Notice! This schematic
matches board version 1.4
VS1010Dev1_43
10.12.2018 13.53
Sheet: 1/3

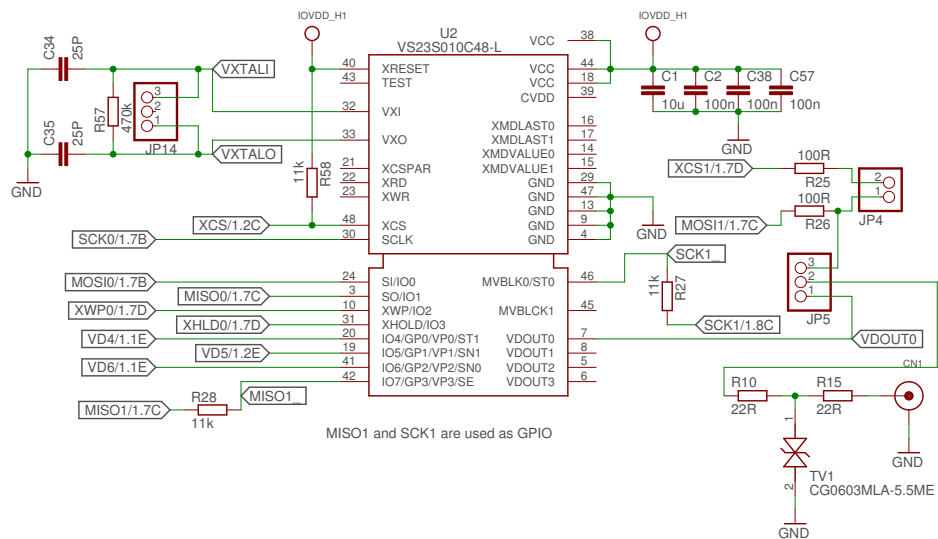
INCORRECT CONNECTION
In VS1010 C and D
XRESET should be pulled up to CVDD
Will be corrected in v1.5

UNRELIABLE VALUE
Power button pulse
too short. Use 10 μF
Will be corrected in v1.5

INCORRECT CONNECTION
Crystal load capacitors should
ground to digital ground
Will be corrected in v1.5

INCORRECT CONNECTION
USB host connector X2
has D+ and D- crossed.
Will be corrected in v1.5

Performance problem: DON'T PUT CAPACITORS ON SPI BUS
Using capacitors to dampen switching oscillation is generally good design.
Here buttons are on SPI bus and capacitors degrade SPI communication
